JOINT REGIONAL PLANNING PANEL (Sydney East Region)

JRPP No:	2015SYE158
DA No:	DA15/1345
Local Government Area:	Sutherland Shire
Proposed Development:	Demolition of existing structures, construction of a mixed use development containing 2 buildings with one commercial unit and 88 residential units and basement carparking
Street Address:	Lot 1 DP 212353 - 34 Railway Crescent, Jannali
Applicant/Owner:	Mr K Pitkanen
Number of Submissions:	Eight
Regional Development Criteria (Schedule 4A of the Act)	General Development over \$20 million
List of All Relevant s79C(1)(a) Matters	<ul style="list-style-type: none"> • State Environmental Planning Policy (Infrastructure) 2007 • State Environmental Planning Policy No. 65 – Design Quality of Residential Flat Development • Apartment Design Guide • State Environmental Planning Policy (Building Sustainability Index: BASIX) 2004 • Greater Metropolitan Regional Environmental Plan No. 2 – Georges River Catchment • Sutherland Shire Local Environmental Plan 2015 • Draft Sutherland Shire Development Control Plan 2015 • Council’s Section 94 Contribution Plans

EXECUTIVE SUMMARY

Figure 5: red highlight indicates extent of ADG non-compliance, Building A level 5 & 6.

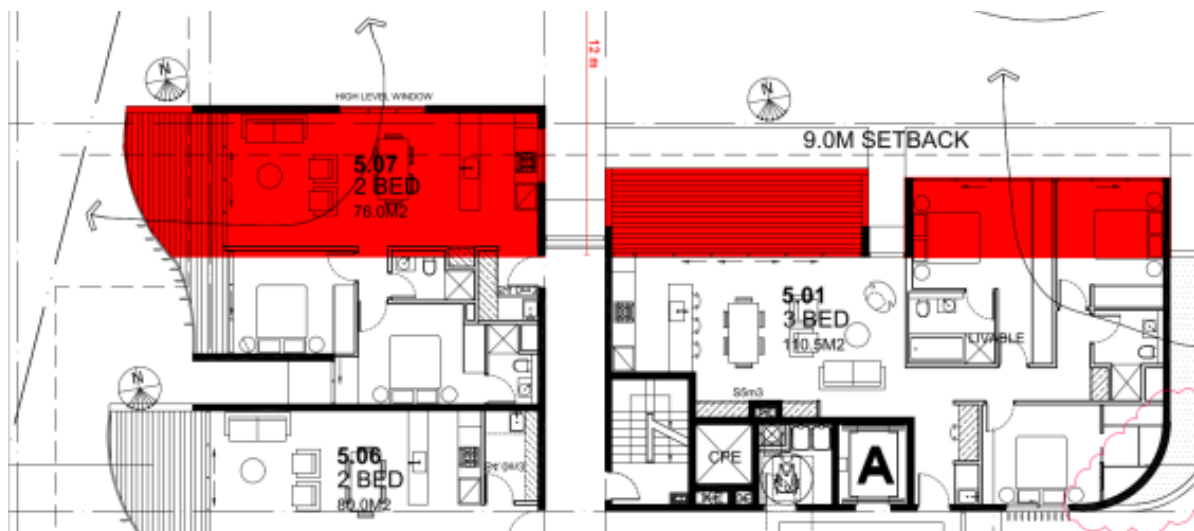
Level 5 and 6 of Building A provide a 2.6- 4.4m shortfall in the ADG recommended setback. Figure 5 below indicates the extent of the non-compliance.

As illustrated above, the element associated with the west facing units, protrudes furthest into the 12m setback zone providing a setback of only 7.6m. Consistent with the approach taken for levels 1-4, Council is satisfied that the defensive design of the west facing units reasonably addresses the intent of the ADG, and is acceptable. A major modification to this element of the design would not result in a significant amenity gain for the neighbouring property but would substantially disrupt the rhythm established by the curved balconies in the façade of the building as they present to Railway Parade.

The non-compliant elements of the north facing units on level 5 and 6 are related to the area of the balcony and two bedrooms which are provided with a 9.4m setback. If the adjoining site was to be developed to its full potential, overlooking would result, and this is primarily a consequence of the balcony orientation. A condition of consent has been recommended to require that this element of Building A is amended to ensure that the development is not less than 12m from the northern boundary. This change would only affect two units, unit 5.01 and 6.01, with the most apparent solution being the reduction in the size of the units from a three bedroom unit to a one bedroom unit to fit within the footprint envisaged by the ADG.

Figure 6: Annotated plan illustrating relationship between north facing ground floor units-Building B to adjoining townhouse courtyards. Red shading indicates area of non compliance with 9m setback. This element is up to 1.8m out of ground.

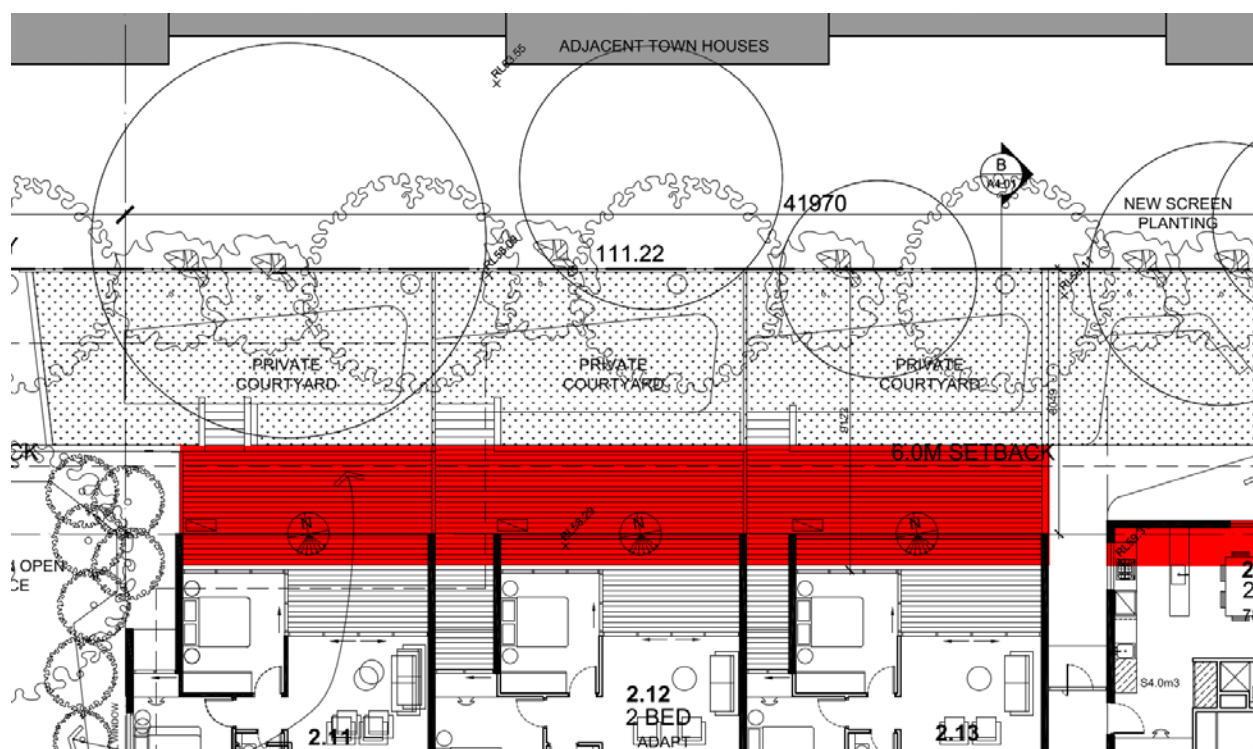
Level 1 (labelled Level 2 on the plans) of the north facing units in Building B provides a 5m setback to the north boundary resulting in a 4m shortfall in the minimum ADG recommendation. Notably, the development is also deficient of the 6m setback prescribed by the “design criteria” that would apply even if the site were not located at a zone interface. The element associated with the level 2 balcony protrudes furthest into the setback zone, which, due to the basement protrusion, is 1.8m above existing ground level. Figure 6 below illustrates this relationship.

The non-compliant elements of the north facing units on level 1 are related to the area of the balcony. Impacts upon visual and acoustic privacy are likely to result. This is primarily a consequence of the orientation of the balconies and primary living areas of these units northward, toward the side boundary where multiple residential private open spaces, living areas and bedrooms exist. A condition of consent has been recommended to require that this element of Building B is amended to ensure that the development is not less than 9m from the northern boundary. The provision of a smaller sized balcony, or design which sets the deck at or near ground level would achieve the 9m setback without a significant impact on the development yield; however the applicant has failed to adopt any such changes.

Figure 7: Annotated plan illustrating area of non compliance with 12m setback for Building B-level 5 (plans marked as level 6).

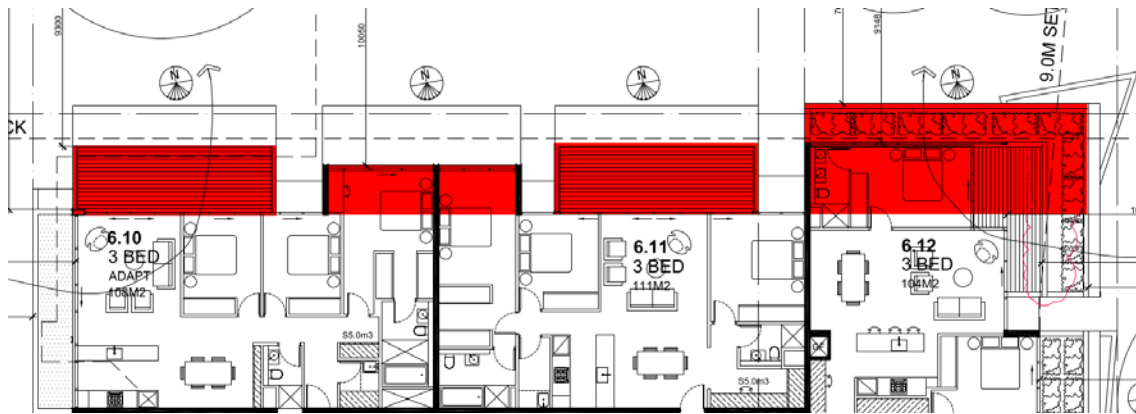
Levels 5 and 6 provide setbacks of variable dimensions, ranging from 9.1m to 10.0m where 12m is required. A more significant redesign is required to accommodate a 12m setback at these levels. Figure 7 below indicates the degree of non-compliance on level 5.

Consistent with the approach taken for levels 1-4, Council is satisfied that the defensive design of the west facing units reasonably addresses the intent of the ADG, and is acceptable. Overlooking and privacy impacts however are anticipated for the north facing units. A condition of consent has been recommended to require a 12m setback is provided.

Figure 8: Annotated plan illustrating area of non compliance with 12m setback between building A and Building B (level 1-4) (red shading).

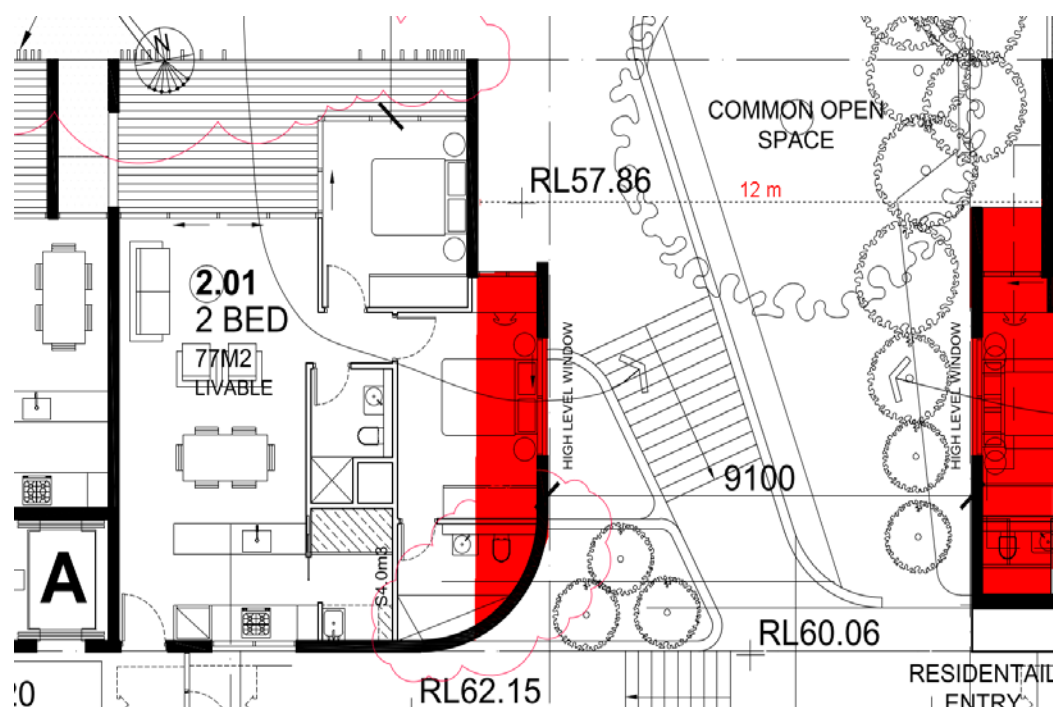
The building separation distance between building A and B is inconsistent with the ADG. The inconsistency illustrated at levels 1-4 is isolated to a 7m length of Building A which extends into the setback zone by 2.9m. The remainder of the building provides a compliant 13.6m separation distance. The non compliant element of the building is associated with a bedroom and is opposite another bedroom in Building B.

The proposal has employed design strategies, such as orienting active living spaces to the north to minimise privacy impacts within the development and providing highlight windows to the non compliant building elements. These strategies are successful in maximising visual privacy in lieu of the minimum separation distance called for by the ADG, and are supported.
